D060145-A

PLEASE NOTE D050444 IS SHOWN.
FOLLOW INSTRUCTIONS ON REPLACEMENT
SHEET FOR D050444.

UNLESS OTHERWISE SPECIFIED DIMENSIONS ARE IN INCHES		DATE	NAME	PARTS LIST	
DRAWN	2-16-06	KEM	LIGO CALIFORNIA INSTITUTE OF TECHNOLOGY MASSACHUSETTS INSTITUTE OF TECHNOLOGY		
CHECKED			SYSTEM	LHD /LLO	
			SUB-SYSTEM	TCS	
			NEXT ASSY	NONE	
			PART NAME	QUAD SUS FIXTURE ASSEMBLY	
			SIZE	DWG. NO.	REV
			D	D060145-A	
			SCALE:	SHEET 1 OF 2

MODIFY EXISTING PLATE

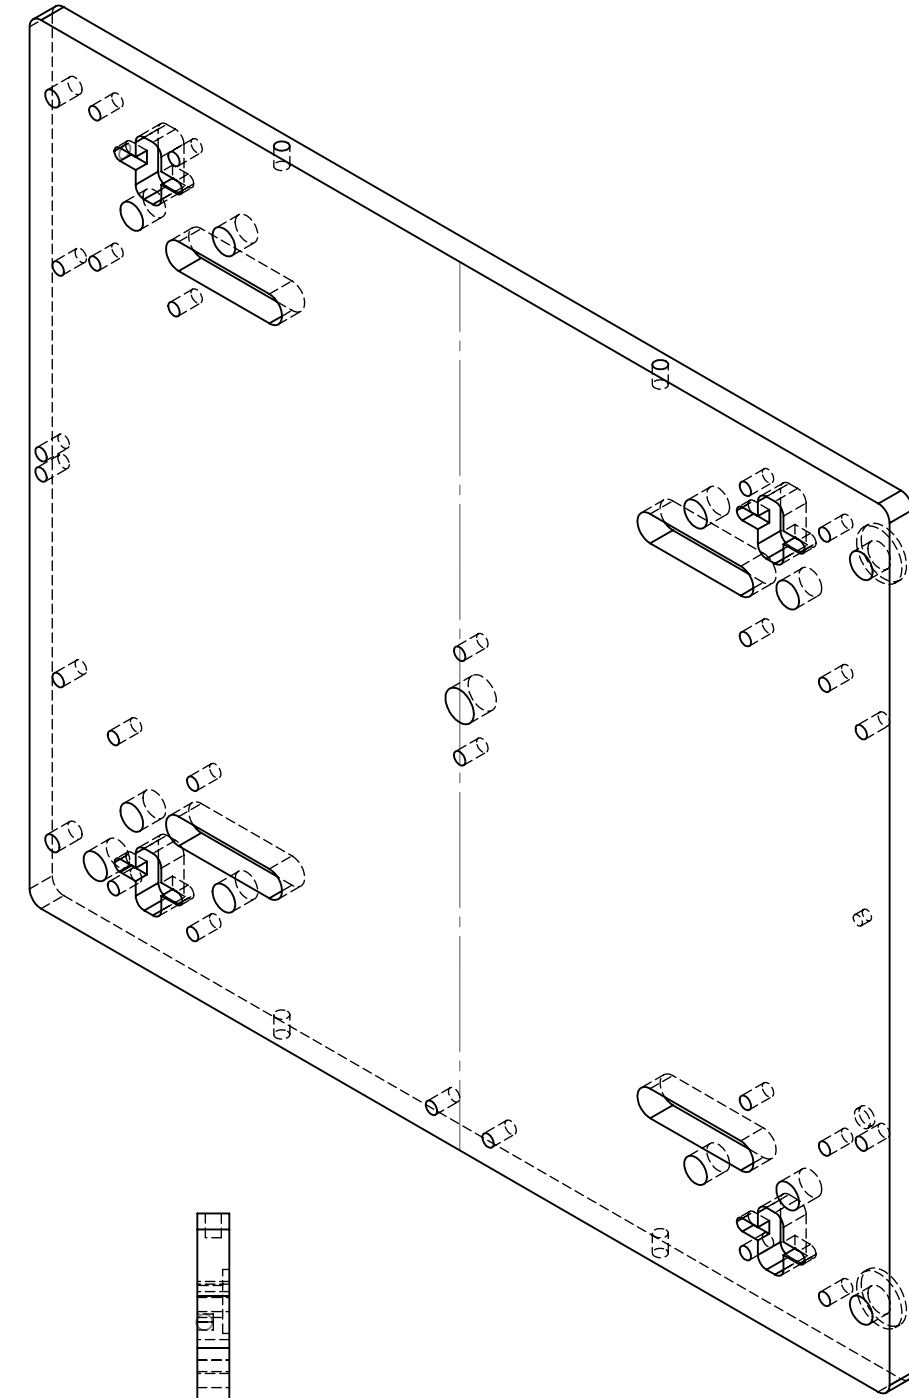
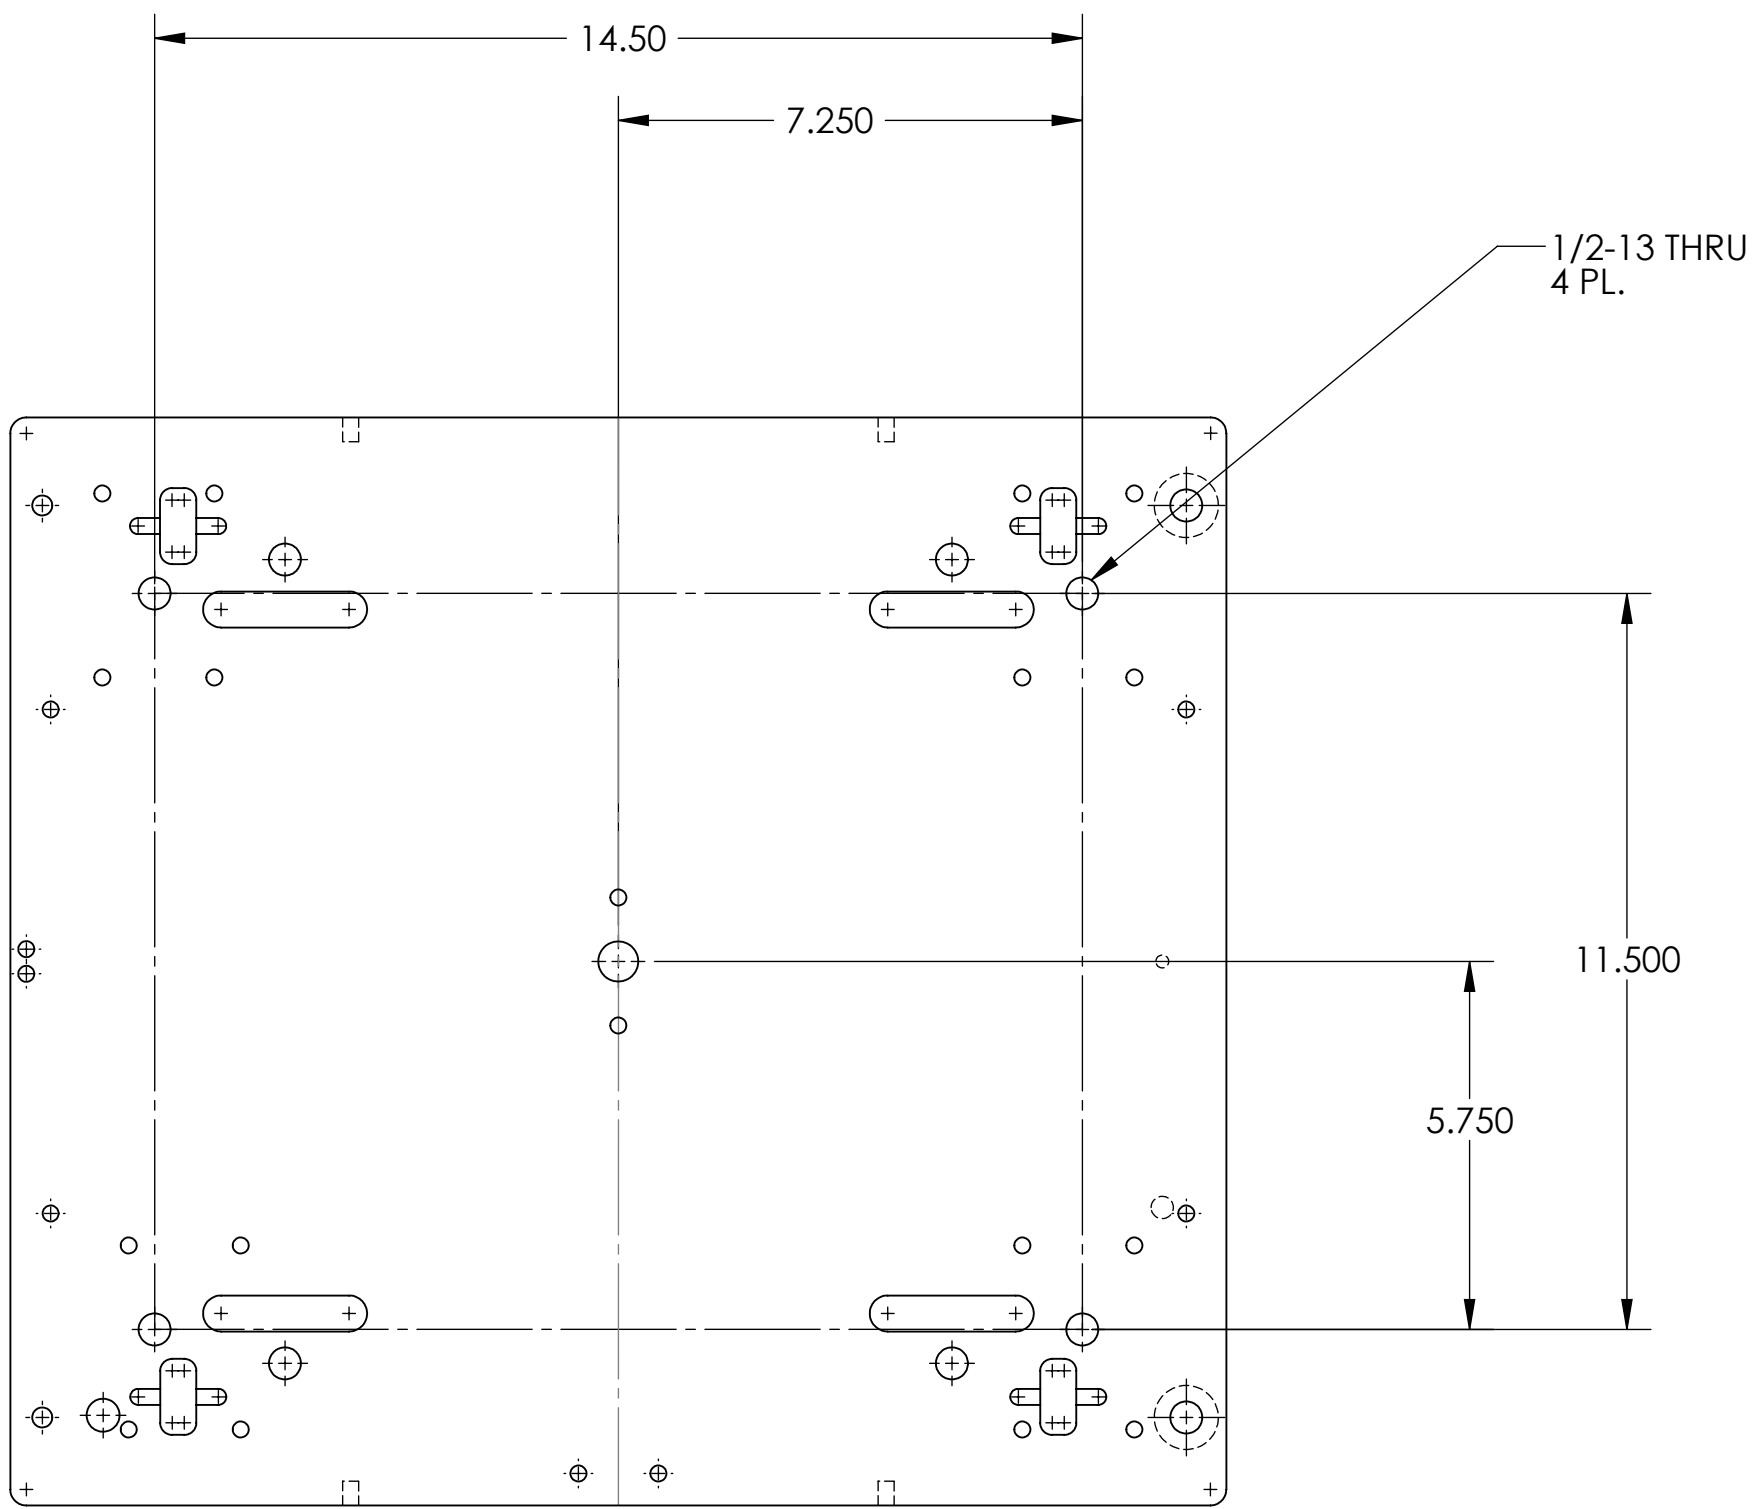
THIS IS A MODIFICATION TO D050446-A AND SHOULD BE INCLUDED AS PART OF THE QUOTE.

D050444-A

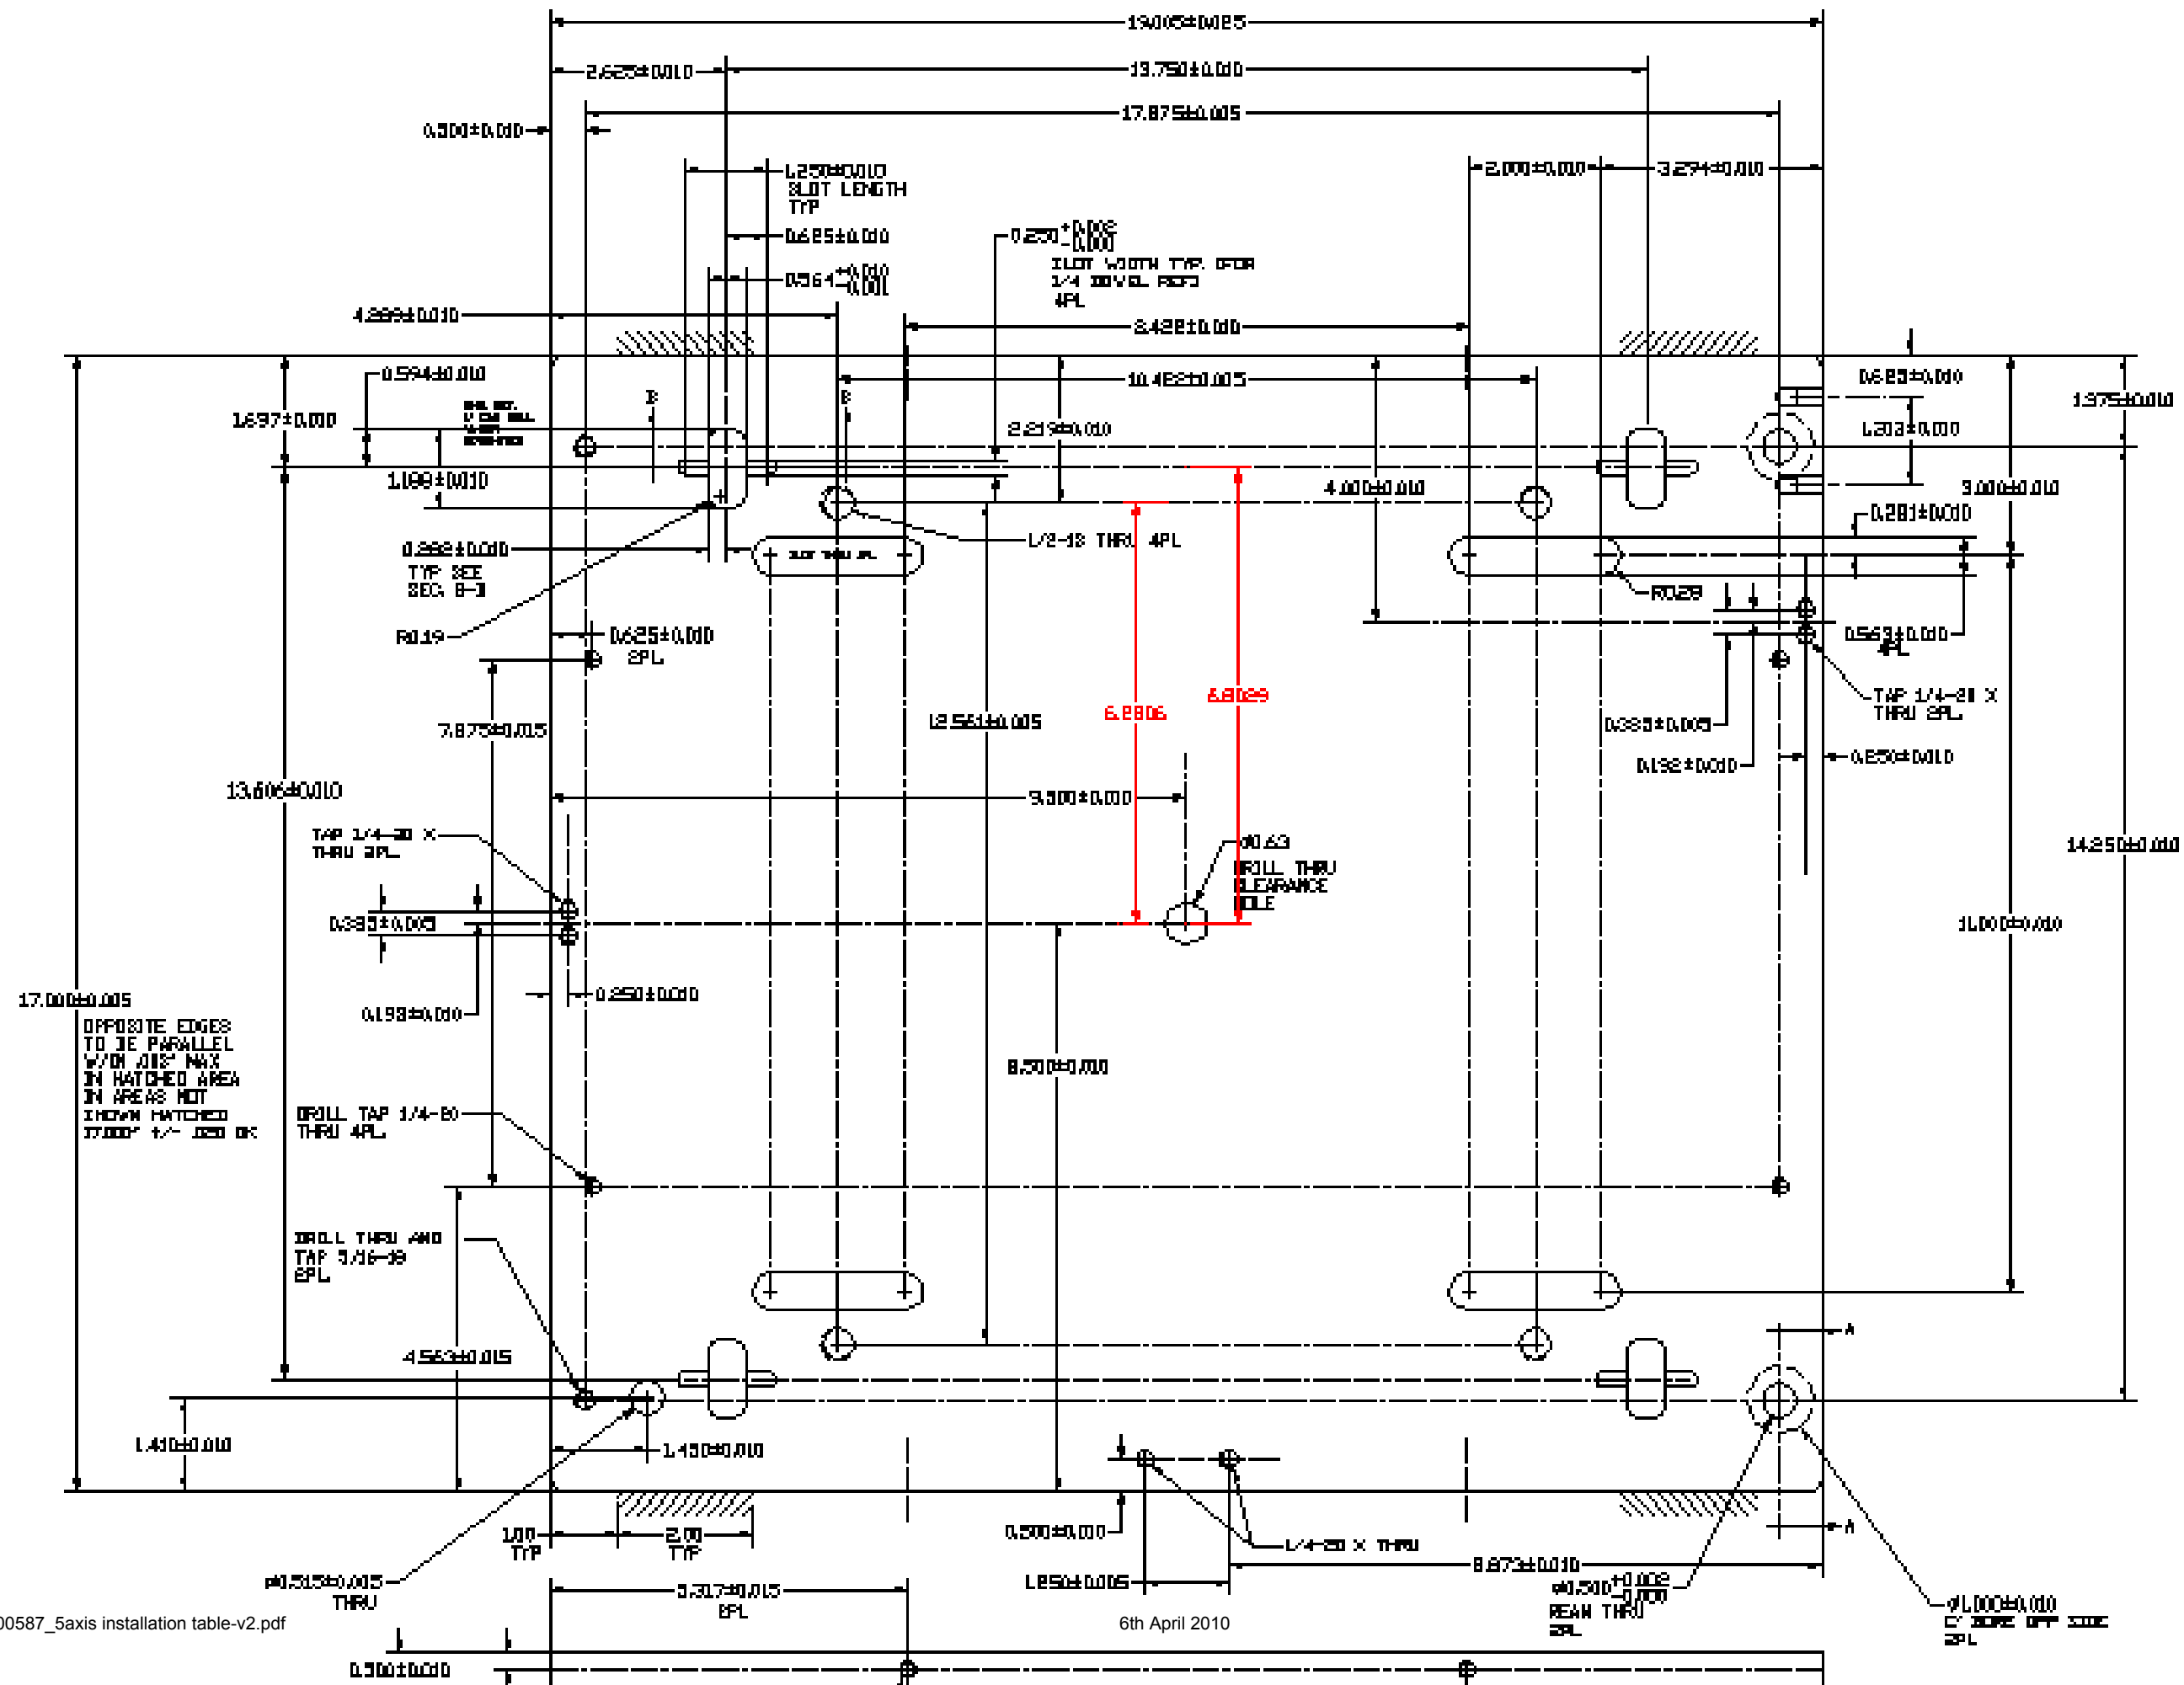
DRAWING D050444-A HAS BEEN REMOVED.

INSTEAD OF MAKING D050444-A AS SHOWN IN THE BILL OF MATERIALS PLEASE MAKE A SECOND COPY OF D050446-A (INCLUDING THE REVISION).
